HERITAGE HIGH SCHOOL NEW CLASSROOM BUILDINGS, INCREMENT 2 Bid Clarification 04

June 3rd, 2021

DSA File Number: 7-H4
DSA Application Number: 01-119268
PTN: 61721-77

Owner:
Liberty Union High School District
20 Oak Street
Brentwood, CA 94513

BC 04.2

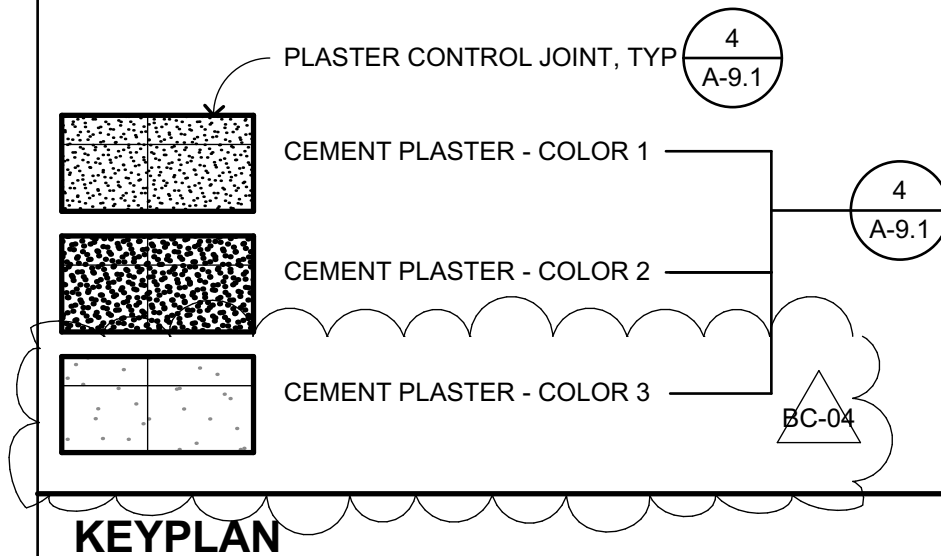
All Exterior Elevation Sheets - Exterior Elevation Legend:

Replace all Exterior Elevation Legends with the attached BC 04.2 EXT ELEV CP3. A third color of exterior cement plaster was added.
